AENC-NG-CNS-REP-0371

Norwich to Tilbury

**Document: 8.3.65 Signed Statement of Common Ground -
Southfields Development Group - Clean Version**

Image 1 Interaction between TB259 to TB261 and the Southfields development

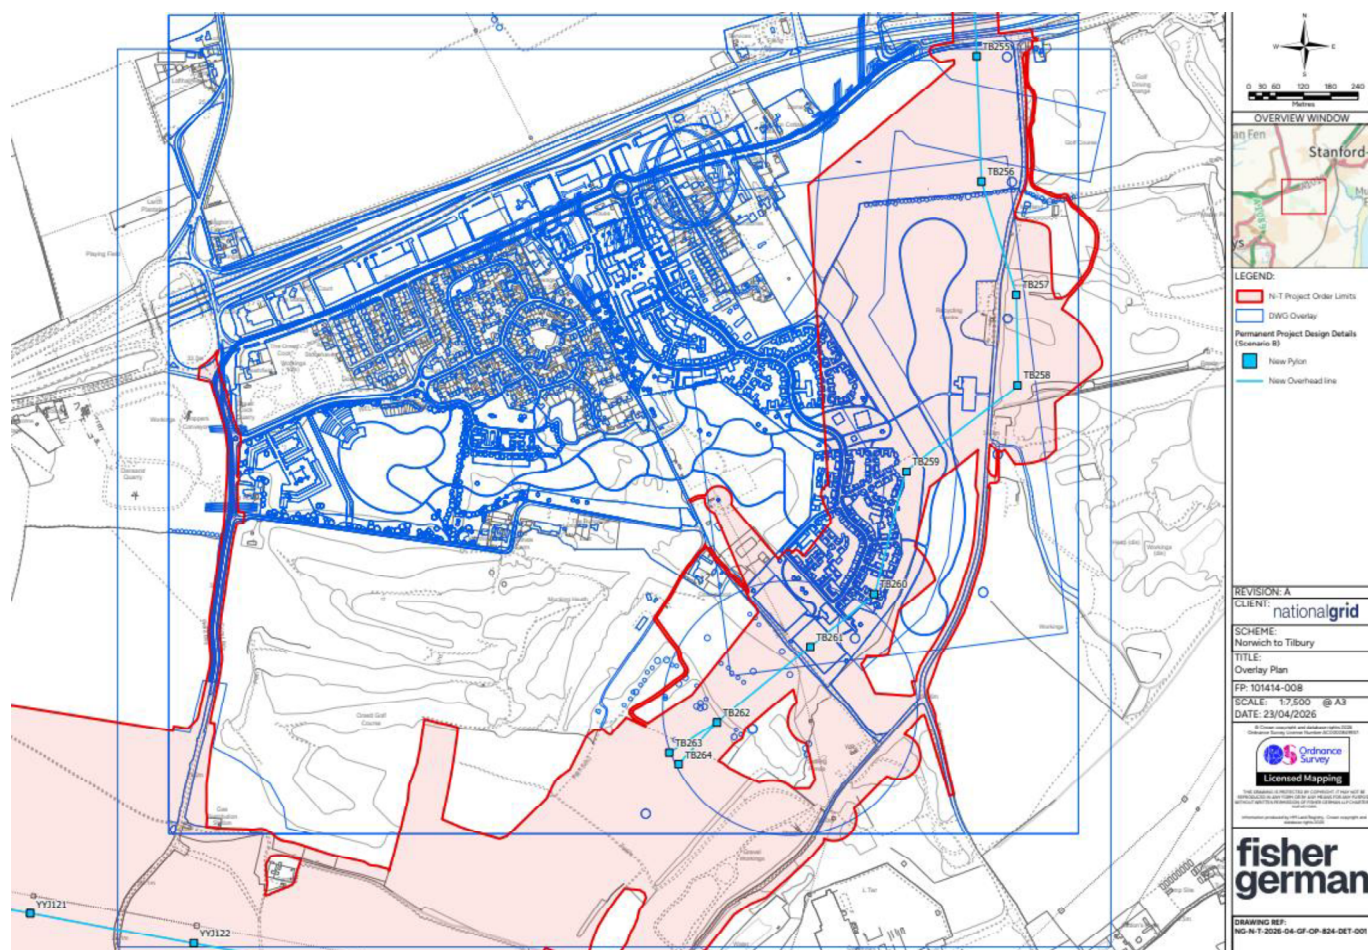
ID	Issue	National Grid position	Southfields Development Group position
9.1	Route alignment, pylon positions and oversail	The Applicant acknowledges Southfields Development Group's concerns regarding the alignment of the proposed overhead line and its potential interaction with the village and wider regeneration proposals. Throughout the design process, the Applicant has sought to identify an alignment that minimises impacts where practicable. In particular, efforts have been made to keep the overhead line as close as possible to the existing gas pipeline corridor, thereby limiting the extent of additional land affected and consolidating infrastructure where feasible. However, there are a number of technical and environmental constraints that limit flexibility in this location. Due to local topography and ground conditions, it has not been possible to route the line across the landfill. These constraints significantly restrict the range of alignment options in this area. With regard to tower position TB261, its location has been determined through detailed engineering design, including span length, safety, and structural requirements. Relocating this tower outside of the refuse tip area is not feasible without exceeding acceptable span distances or necessitating additional	The 'line' presently shown as running across the southern part of the 800 dwelling village site, and the Thurrock Council owned filled refuse tip, which is to the immediate east of the village site, blight the whole of the village site to the point of making the proposed dwellings unsaleable, in addition the agreement for Thurrock Council and National Grid to jointly participate in regeneration of the 80 acre filled tip area would also be prejudiced by the presently proposed positions of two of the new pylons and the proposed pylon line. Prima facie it looks as if the new pylon cable line could continue further south along the east side of Buckingham Hill Road to cross the BHR just to the south of the junction of Holford Road with the Buckingham Hill Road. The latter line would remove the blighting effect upon the proposed village site and the regenerated for recreation purposes Buckingham Hill Road 'Council owned refuse tip, while occupying land which is presently vacant and unlikely to ever be considered for residential development. I cannot see any material difference in the construction cost to 'Grid of the overhead line as presently indicated, as against moving the 'line' to continue further south along the east side of Buckingham Hill Road. Given the height, substantial nature and position of the pylons and the 'line' as presently proposed, my proposed scheme for the new

ID	Issue	National Grid position	Southfields Development Group position
		infrastructure, which could result in greater overall environmental and visual effects. With regards to tower TB259, there are restrictions as to possible relocation due to the presence of a high-pressure gas main to the east of the proposed location. The Applicant notes the concerns raised in relation to the potential implications for the proposed development and has, to date, sought to take account of emerging master planning where reasonably practicable within the design process. However, given the constraints outlined above, there is limited scope for further modification to the alignment in this area. The Applicant remains committed to ongoing engagement with stakeholders and will continue to consider any reasonable opportunities to reduce effects where practicable through detailed design.	Southfields Village and a Country Park which will, all being well, include the regenerated refuse tip as referred to above, will not be viable. People do not like living near pylons and overhead lines and the incidence of the proposals as presently indicated, albeit over a very small length of the overall 'line', renders the ten years of work spent upon creating the new 'Village and Country Park, and obtaining local residents support, as completely wasted.
